THE CORPORATION OF THE TOWNSHIP OF PUSLINCH March 22, 2023 PUBLIC INFORMATION MEETING VIRTUAL MEETING BY ELECTRONIC PARTICIPATION & IN-PERSON AT THE PUSLINCH COMMUNITY CENTRE 23 BROCK ROAD S

- 1. Call the Meeting to Order
- 2. Roll Call
- 3. Disclosure of Conflict of Interest
- 4. Purpose of Public Meeting
- 5. Reports/Applications
 - 5.1 Zoning By-law Application D14/WEL 2795848 ONTARIO INC Wellington Motor Freight Concession 7 Concession 8 Part Lot; 24 Part Road known as 128 Brock Rd S., Township of Puslinch
 - 5.1.1 Application and supporting documents

- 5.1.2 Report Wellington Motor Freight Zoning By-law Amendment Application D14/WEL Puslinch Concession 7 Concession 8 Part Lot; 24 Part Road 128 Brock Road South
- 5.1.3 Public Comments Received
- 6. Adjournment

Zoning By-law Amendment Application

Figure 6: Predicted Impulsive Sources Sound Level Contours with Mitigation

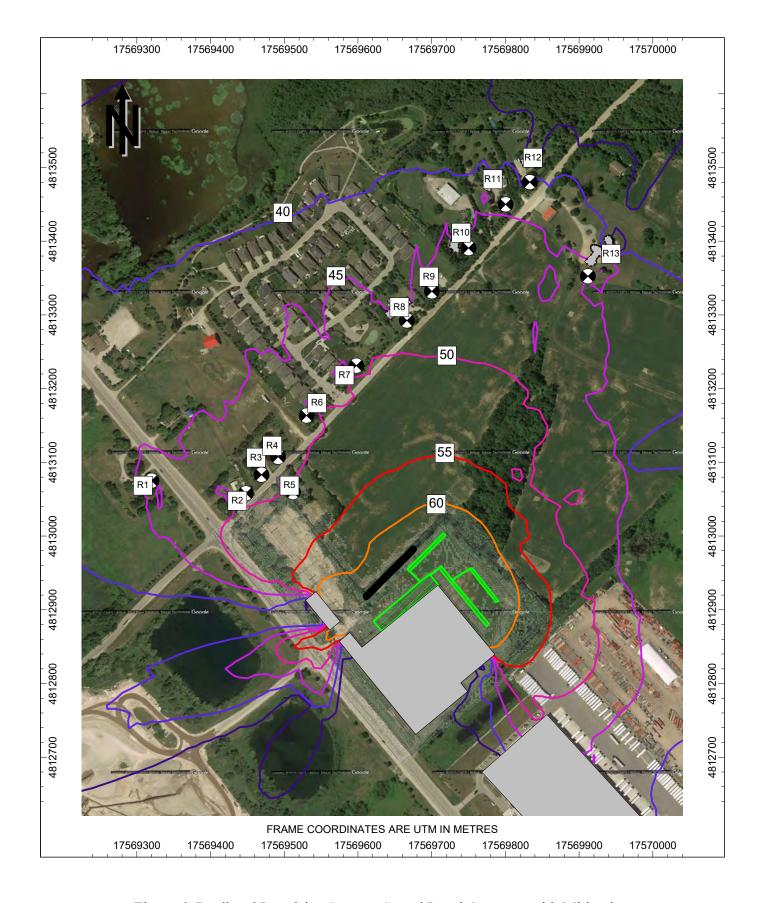
- (5) Appendix A indicates all sources, except vehicle movements, have been modelled as point sources of sound. Review of Figure 6 seems to indicate that the impulses were modelled as a line source(s). An explanation of how the impulses were modelled and why this represents a predictable worst-case scenario is needed.
